NEW GAS STATION, C-STORE, DRIVE-THRU
A.L. PRIME #TBD
23 CENTRAL STREET
BYFIELD, MASS

THIS SET ISSUED FOR SPR & SP 10/7/20 2nd HRG, W/ REVISIONS PER CMTS

PROJECT
COVER SHEET

NORTH ELEVATION (REAR)

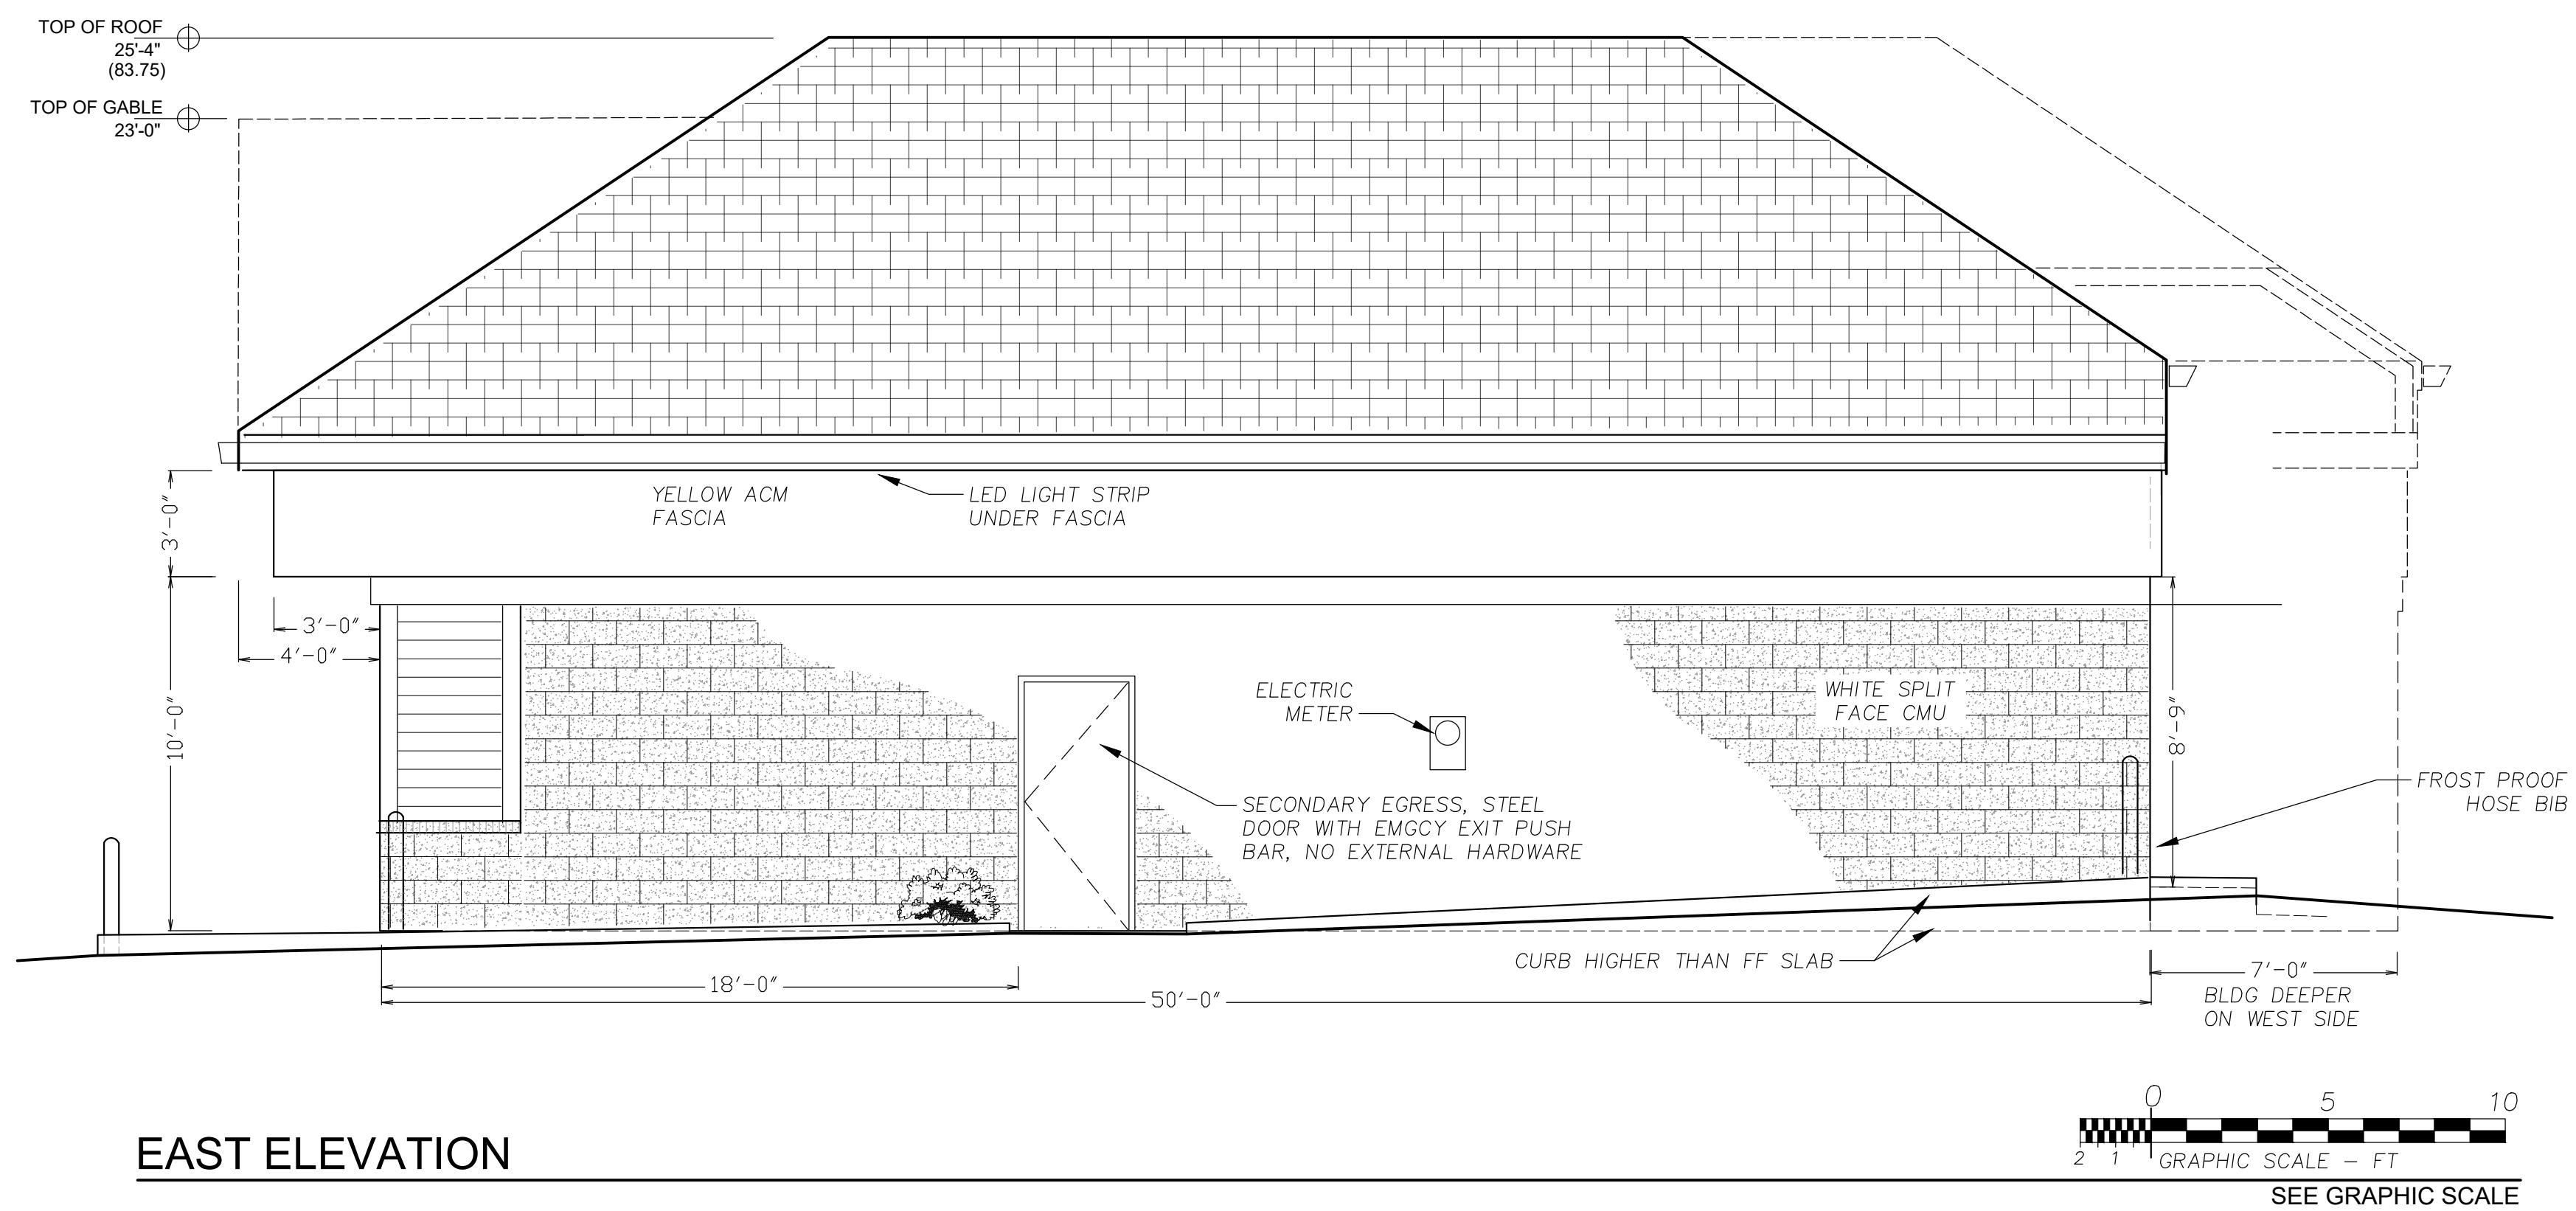
| 23 SEP 2020 23 APR 2020 | 1 0 | AG AG | REVISED ROOF LINES ORIGINAL DRAWING DATE | DWG FILE TBD-019-01 BYFIELD | SHEET A-2.2 |
